Millstone Nuclear Power Station, Unit 3
NRC Chemical Engineering Branch (Fire Protection)
Review Meeting, March 28, 1984

Status of the NRC-CMEB (Fire Protection)
Draft SER Open Items Discussed at the Meeting
with the NRC-CMEB March 28, 1984

Responses to the Draft SER Open Items

Sheet 2 of 2

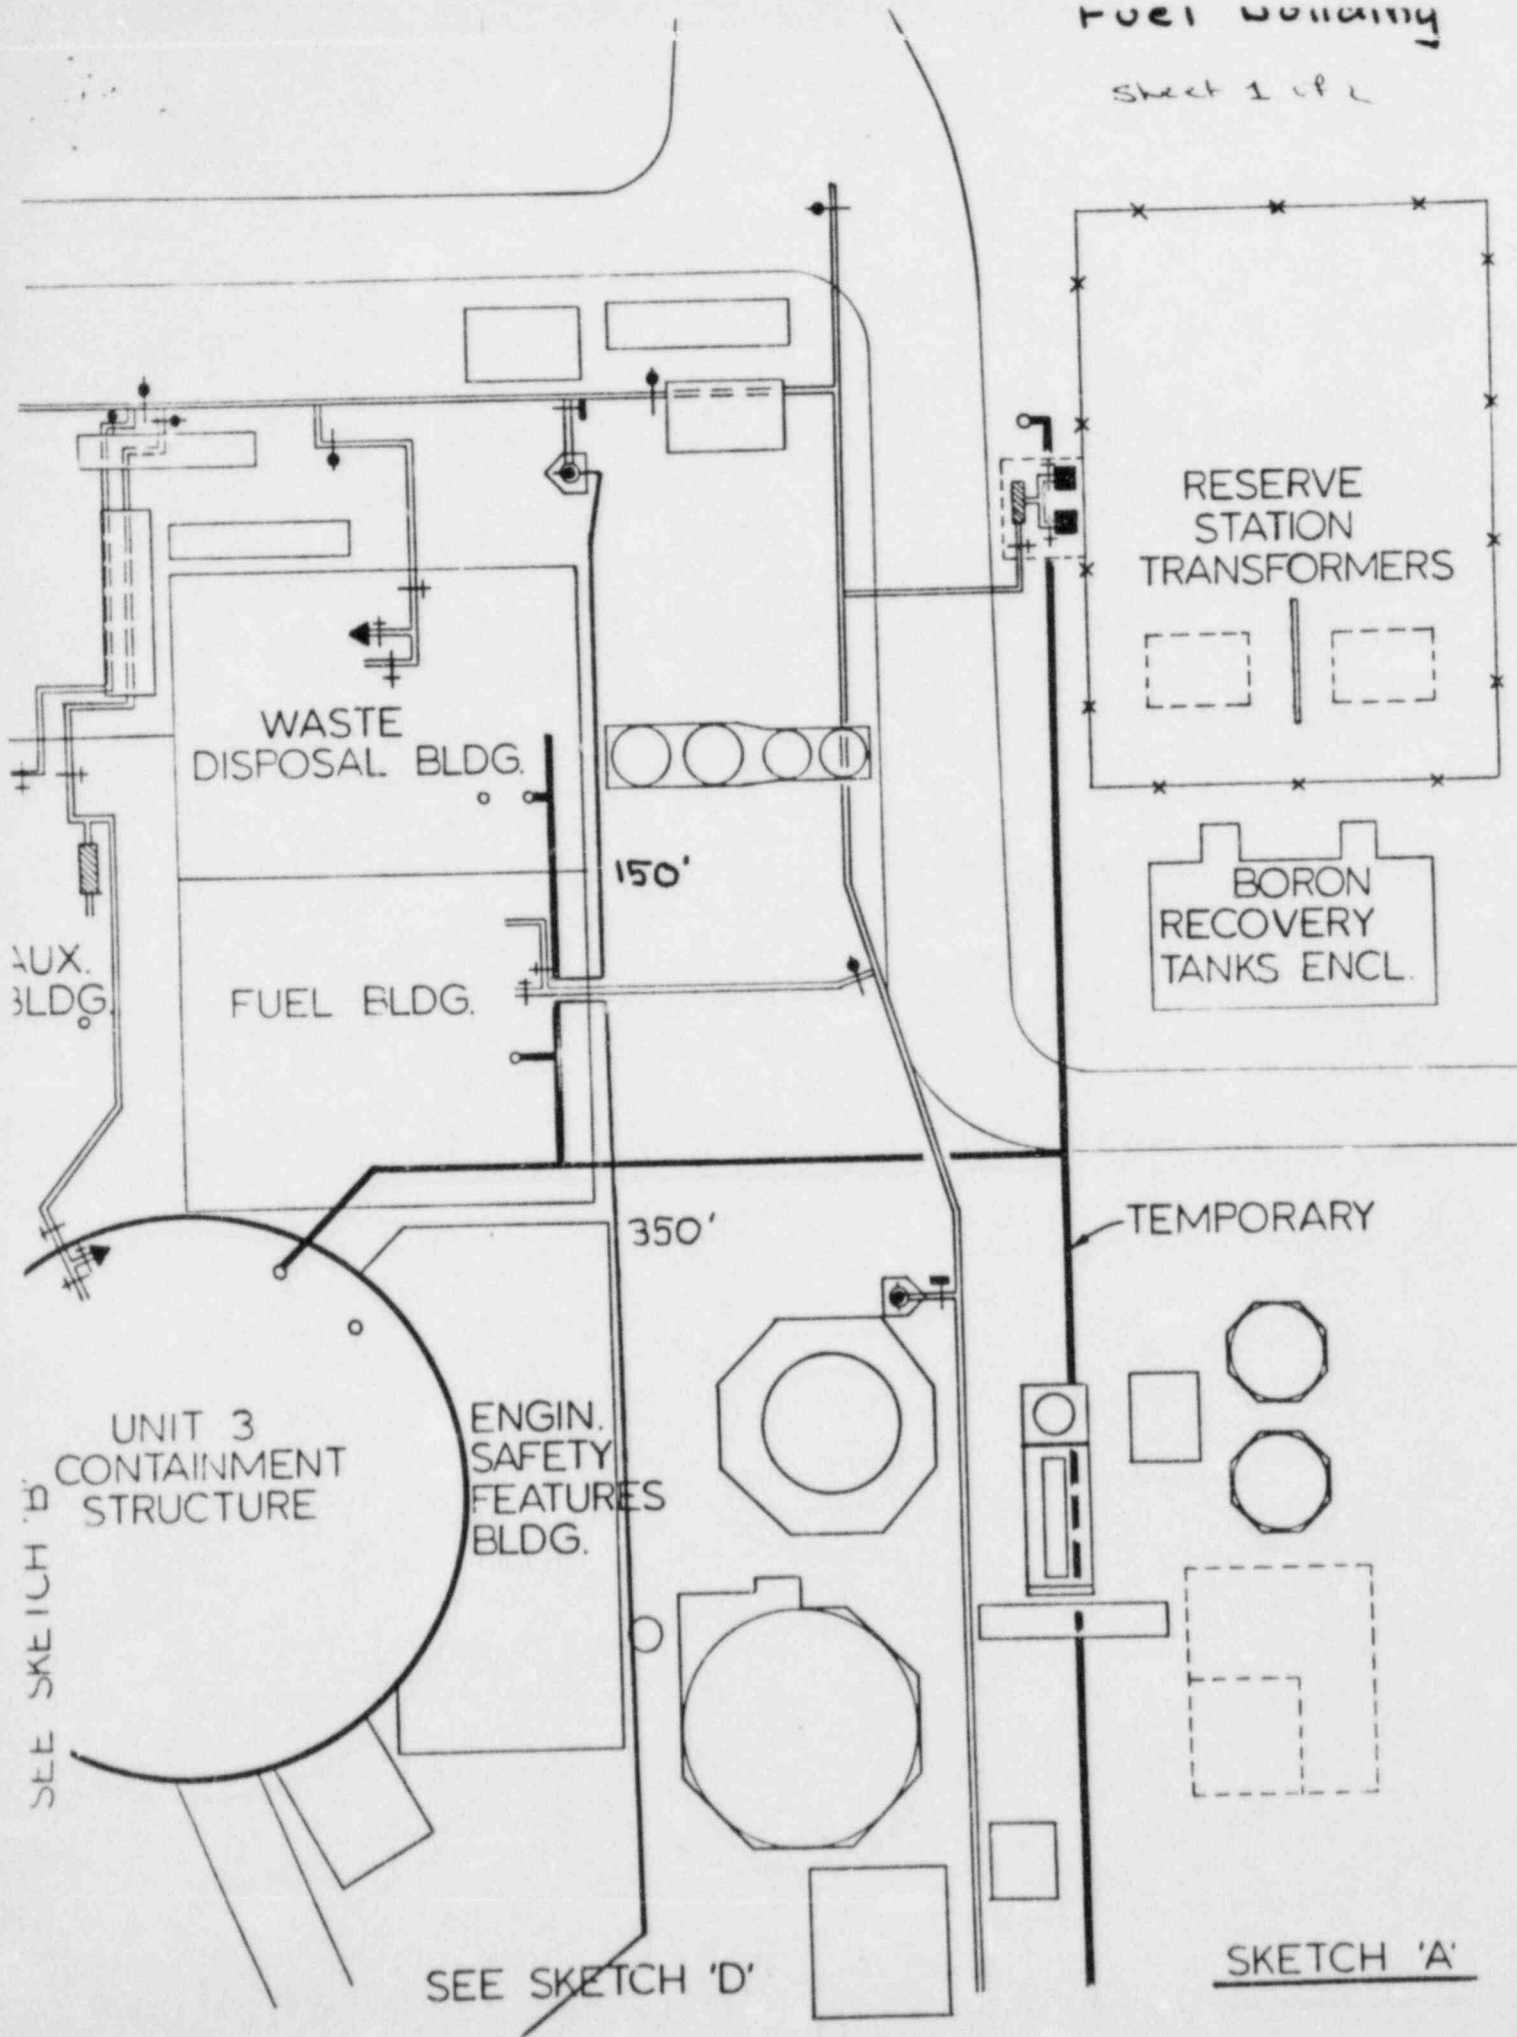
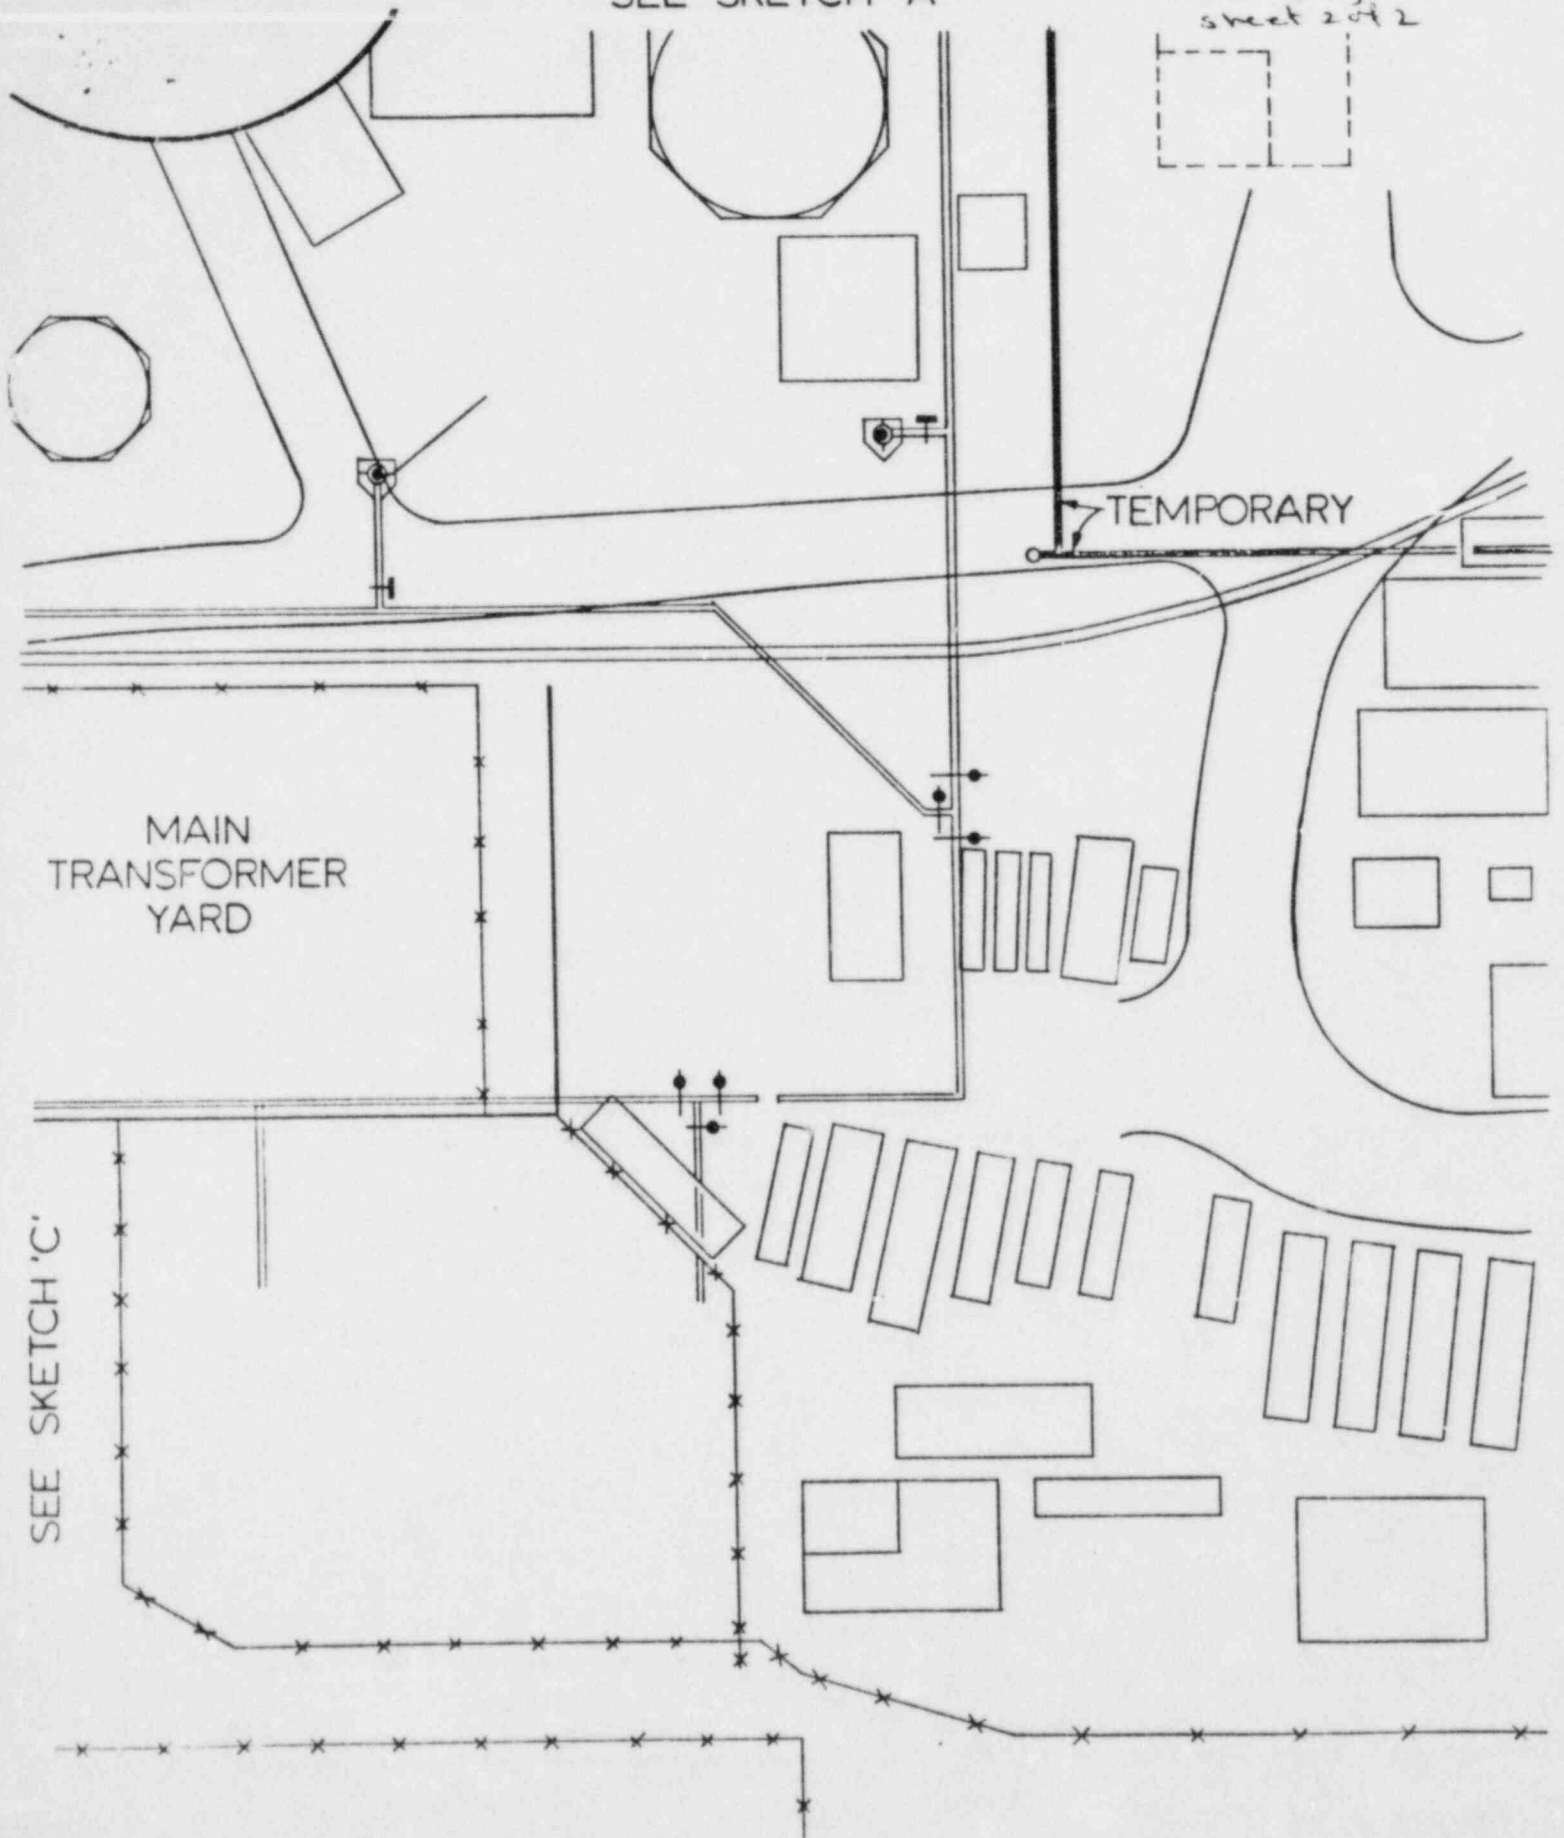
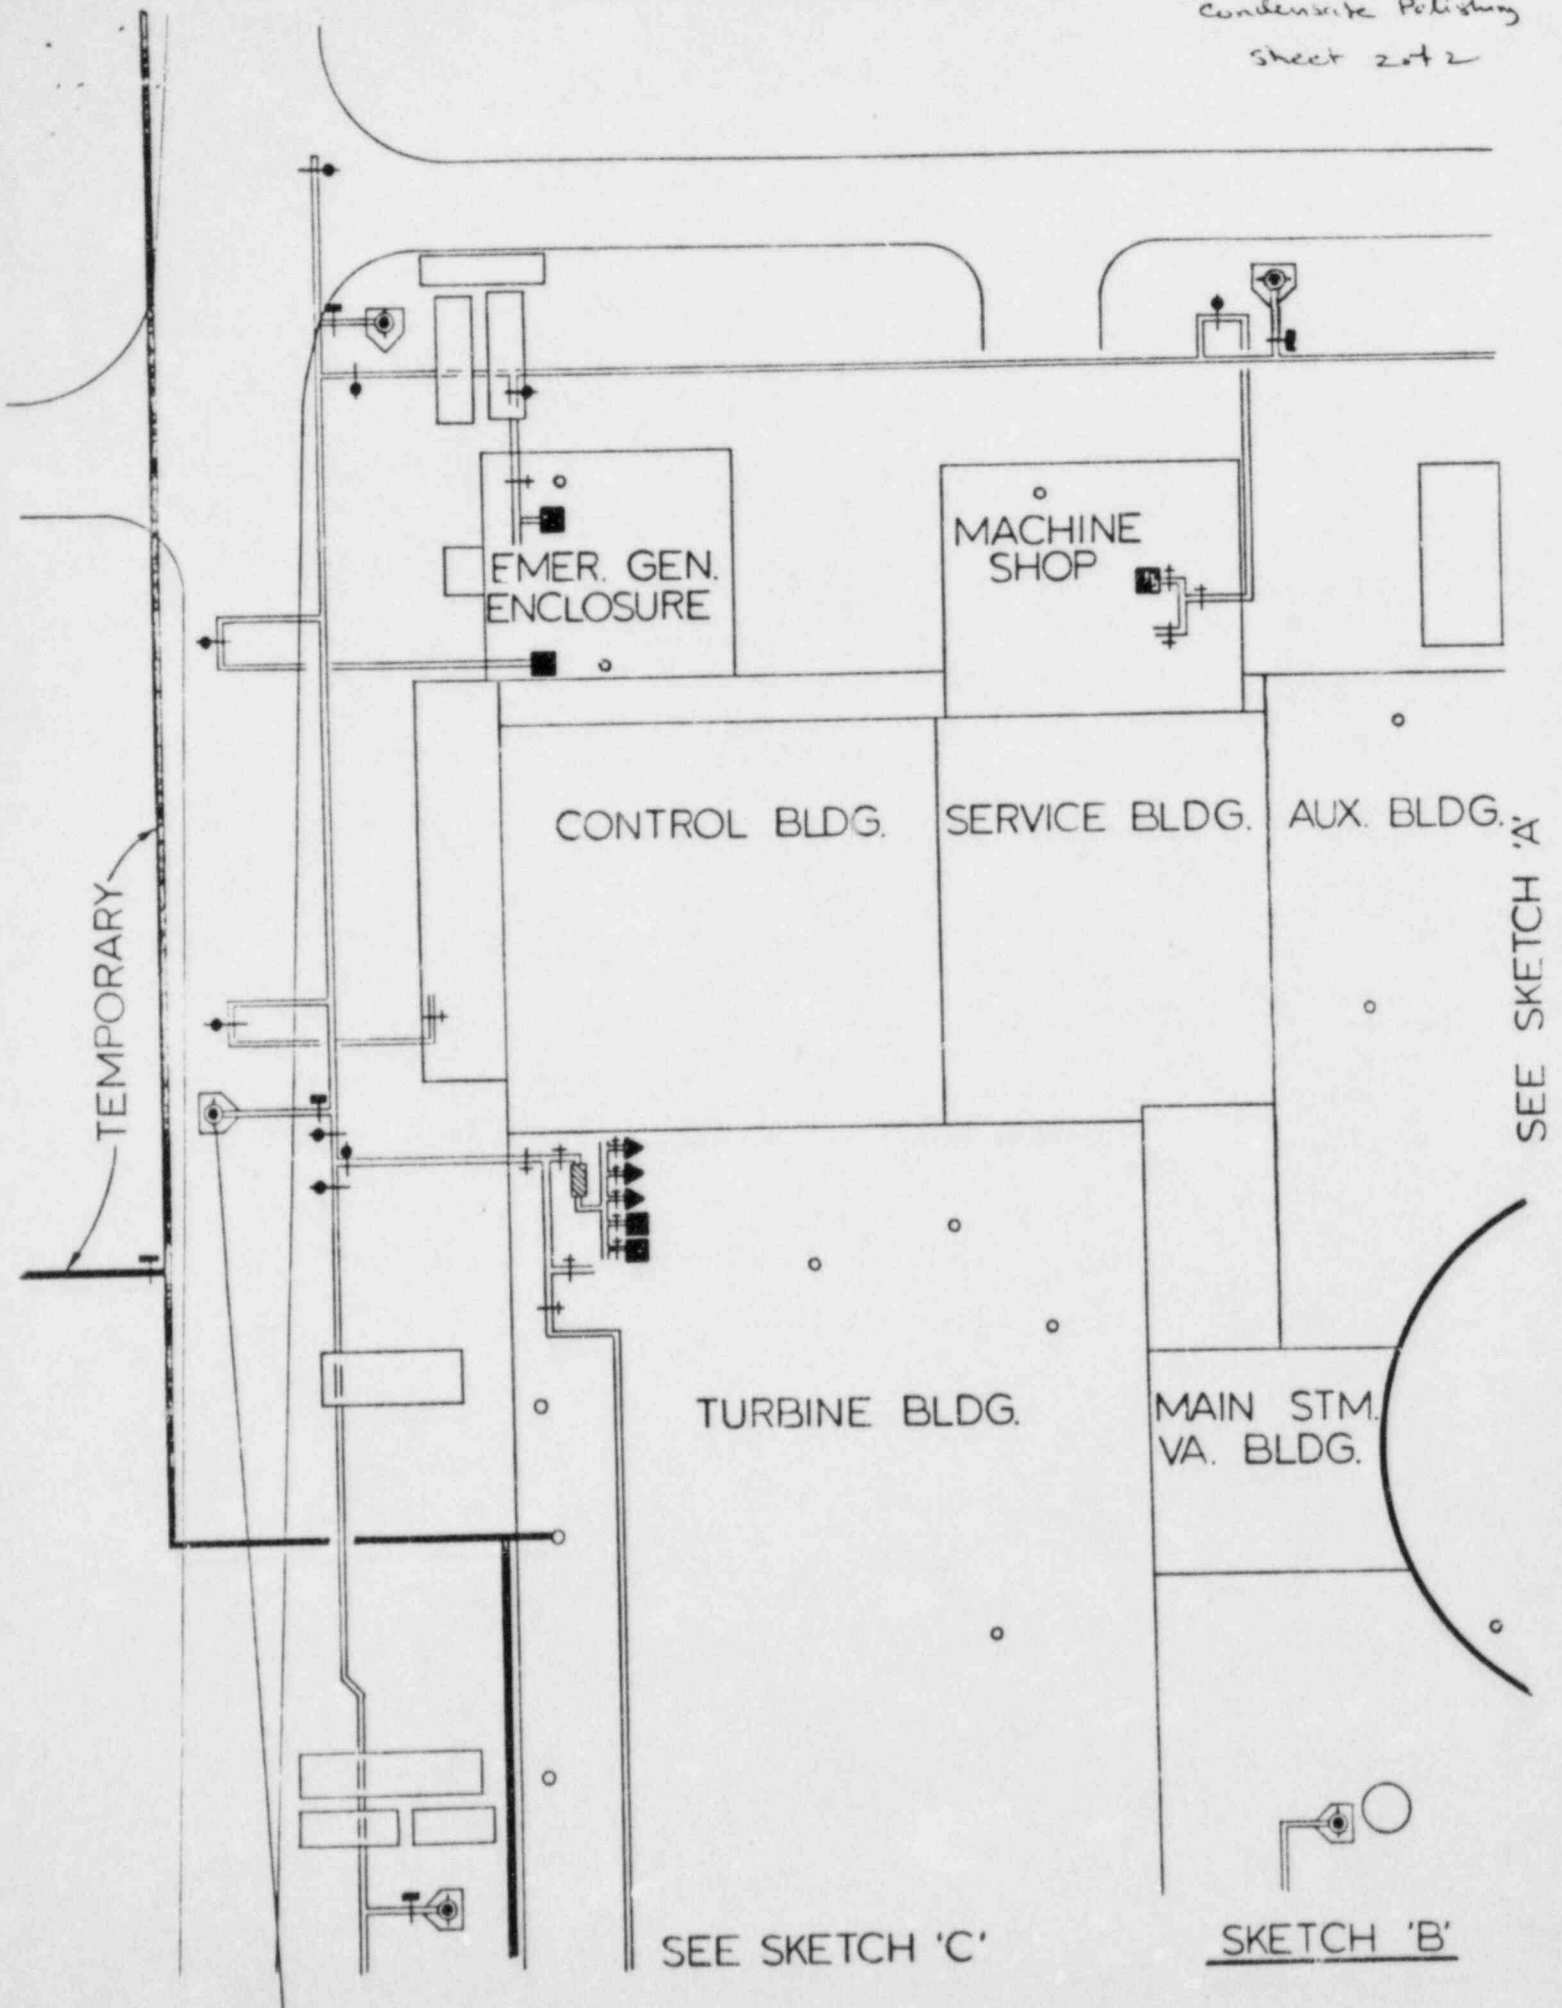
We will require the applicant to provide a fire protection water supply for the emergency generator enclosure, service building, waste disposal building, containment and the auxiliary boiler room such that a single break or failure in the supply piping will not result in the loss of both the primary and secondary water supplies. This is an open item.

The design of the underground fire water supply system at Millstone Unit No. 3, as illustrated on attached sketches A through D, is such that a minimum number of fire water suppression systems would be affected by a single break or failure. This same philosophy has also been utilized in the design of the plants interior fire water suppression systems. It is NNECO's concept should a break or failure occur in the fire water supply piping at Millstone Unit No. 3 to either:

- o Temporarily supply those fire water suppression systems rendered inoperable utilizing large diameter fire hose (2½ inch). Fire hose of sufficient quantity and size would be utilized to adequately supply the inoperable systems. These fire hoses would be supplied from fire hydrants connected to the underground fire water supply system that are unaffected by the break and/or failure. (See Table FP14-1).
- o Provide adequate manual fire suppression capability, in those areas affected by the pipe/break failure, by routing fire hoses from adjacent operable portions of the fire water system.

1. Those portions of the fire water supply piping highlighted in yellow are considered inoperable based upon a pipe break.
2. The primary temporary supply is the shortest route/discharge to an operable yard hydrant/water source.
3. The secondary temporary supply is the alternate source to the primary should it be unavailable.
